SERVICE BULLETIN CHANGE NOTICE

S.B. No. A320-21-1030 REV. 1

TITLE : AIR CONDITIONING - AVIONICS COOLING - IMPROVE EFFICIENCY OF  
WATER DUST STOPPAGE.

REVISION TRANSMITTAL SHEET

Avionics Ventilation System  
Installation of Brackets on Center Line between Frame 23 to Frame 24  
Figure 2, Sheet 4

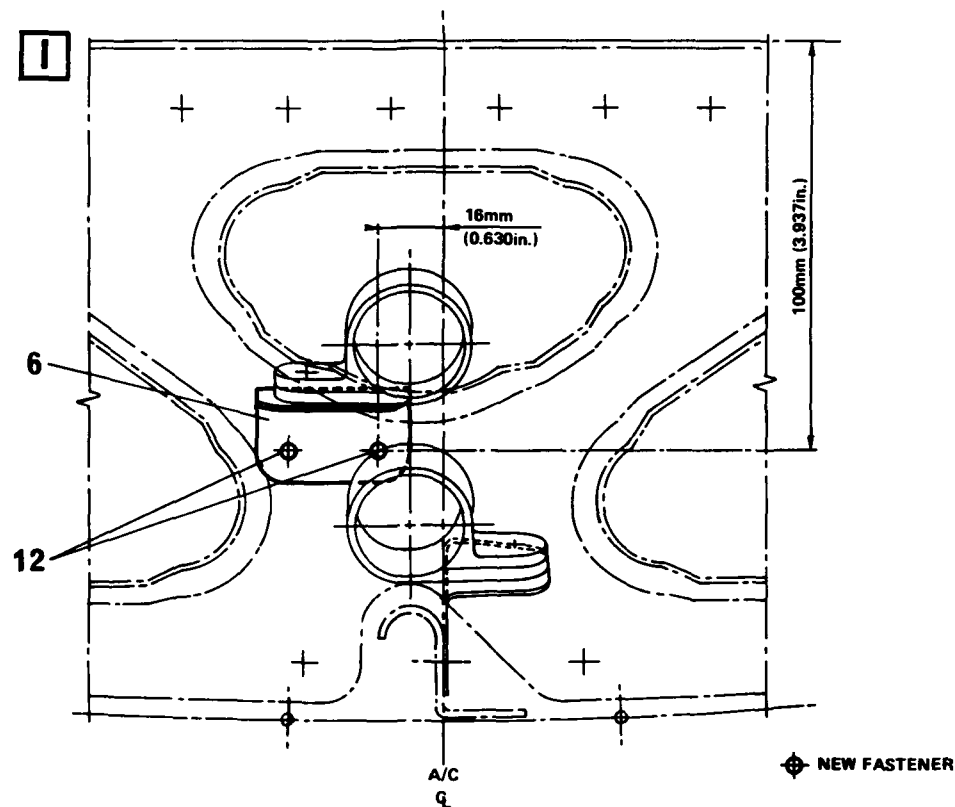
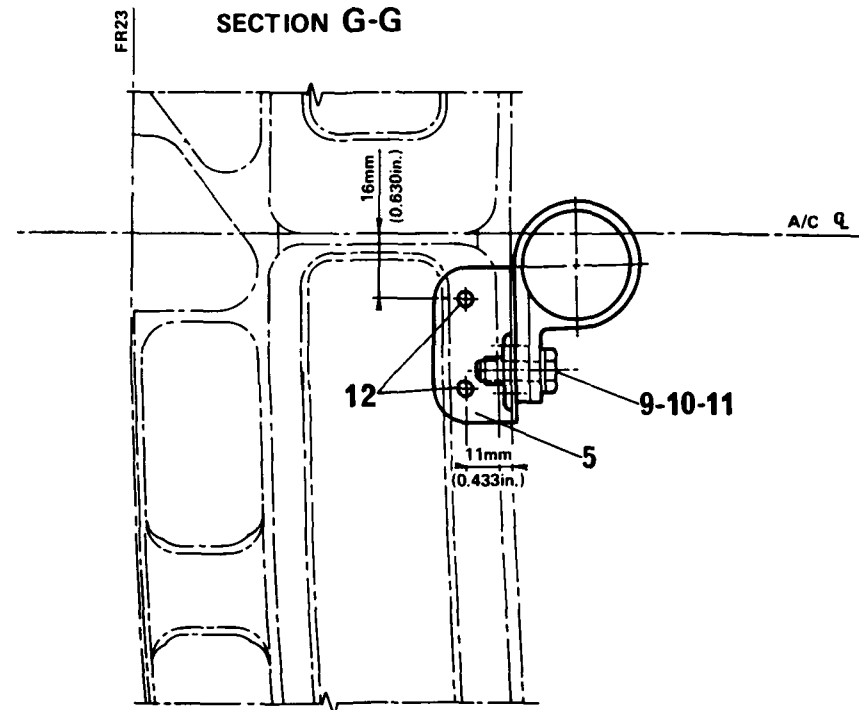
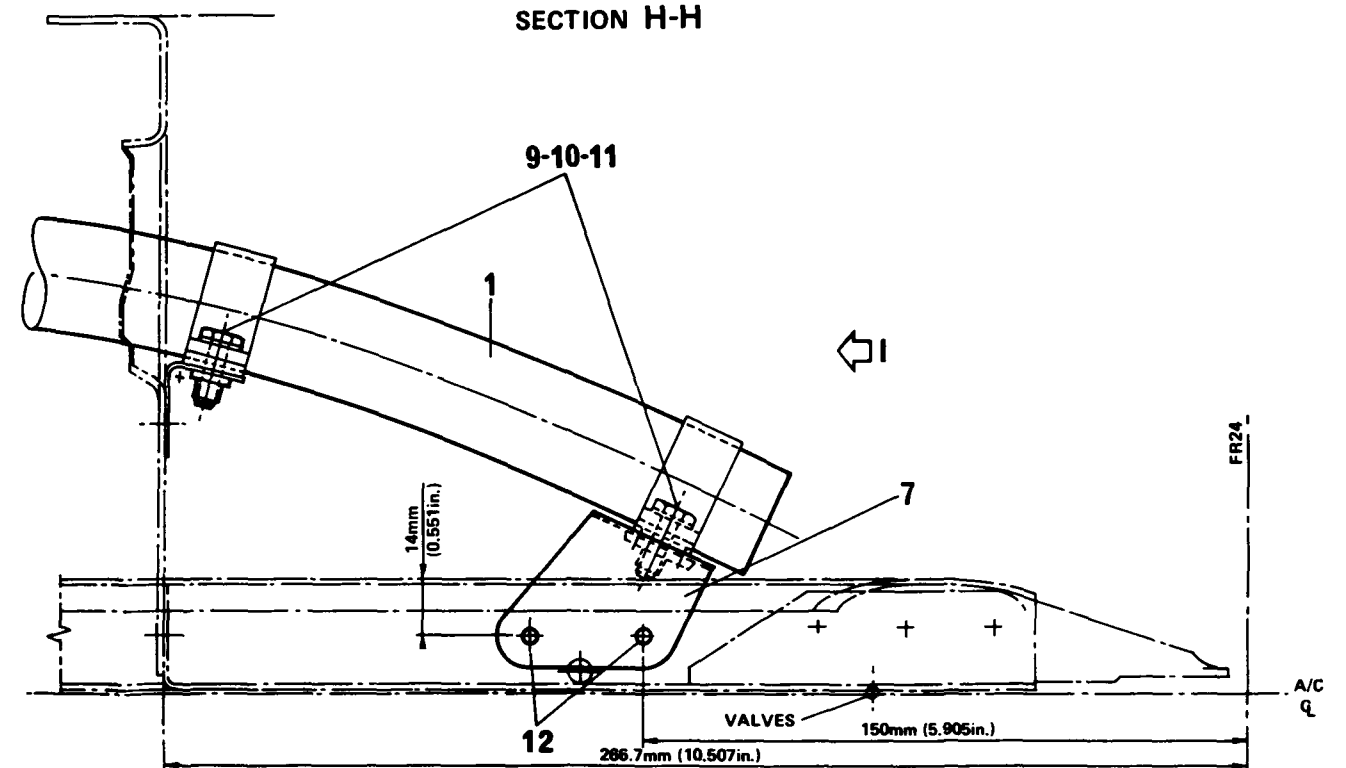
5 On center line, Ref. Fig. 2, Sheets 1 of 4 and 4

At frame 23 (Section G.G)

On center line (Section H.H)

On web of center line between FR23 to FR24 (View I)

Apply Mat. No. 09-013 (Ref. CML) and secure brackets assembly Item 5, Item 6, Item 7 with :
